HARDWARE ERRATA REPORT

P/N **PCM-052**

phyCORE-Vybrid System on Module

Revision A0, 25 November 2013

Figure 1: Errata 02 Rework

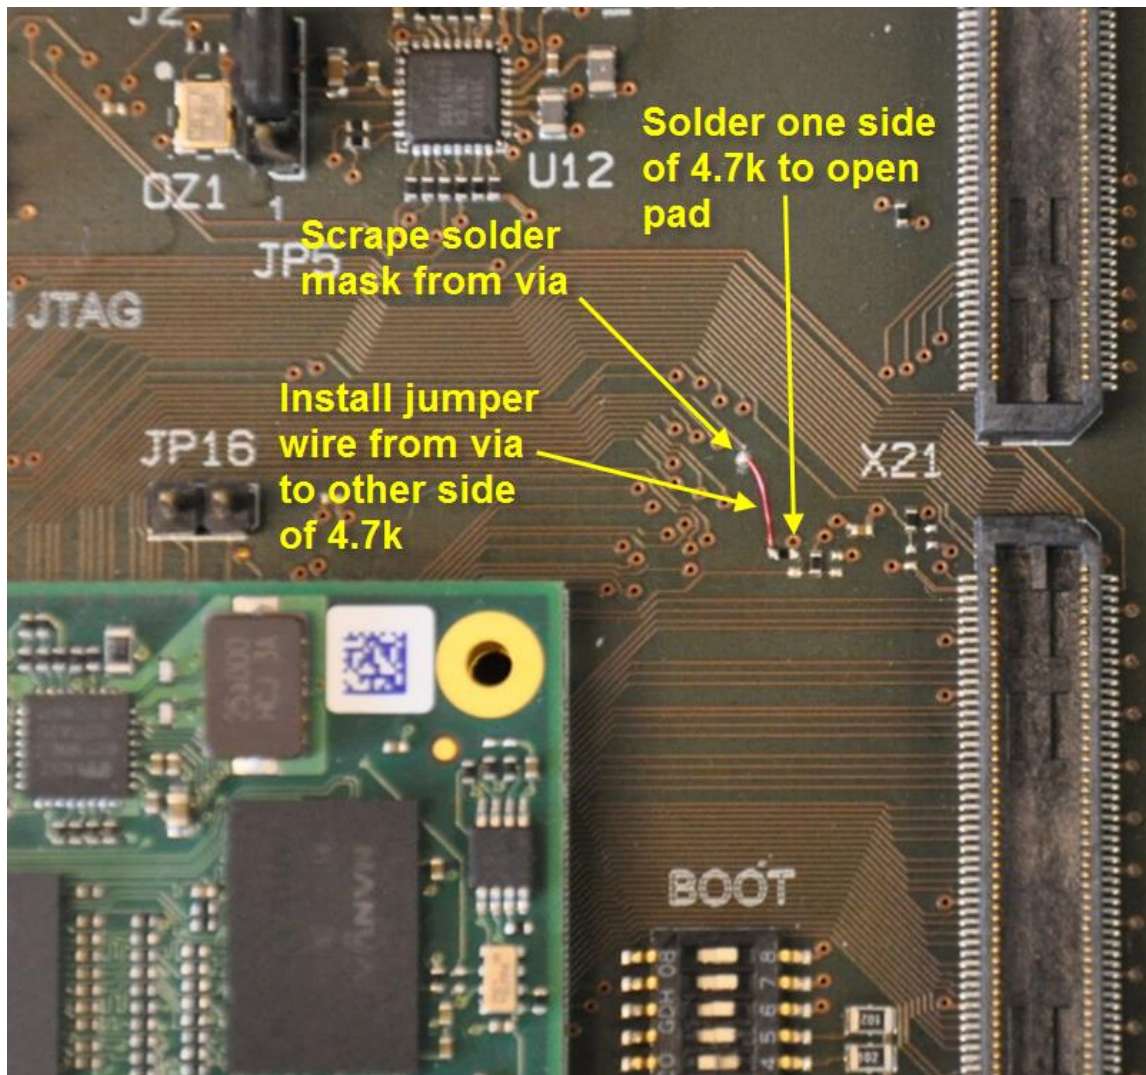
Errata Impact: The Vybrid ROM loader cannot boot a u-boot image from the NAND device.

Errata Description: The NAND controller's $\text{NFC_R}/\overline{\text{B}}$ by default should be high, putting the NAND flash into a ready state. Instead, $\text{NFC_R}/\overline{\text{B}}$ signal floats at power on. The system reads this as busy, and therefore, not ready for commands.

Workaround: Solder re-work must be done on the phyCORE-Vybrid Carrier Board (PCM-952). Add a 4.7k Ω resistor between $\text{NFC_R}/\overline{\text{B}}$ and VDD_3V3. Figure 1 below, shows a 0402 package 4.7k Ω (1/16 W, 1-5%) resistor soldered to the top pad of R114 (not populated) for a connection to VDD_3V3, which is then connected by a wire to the $\text{NFC_R}/\overline{\text{B}}$ signal available at the respective via.

Errata Fix: 1374.1
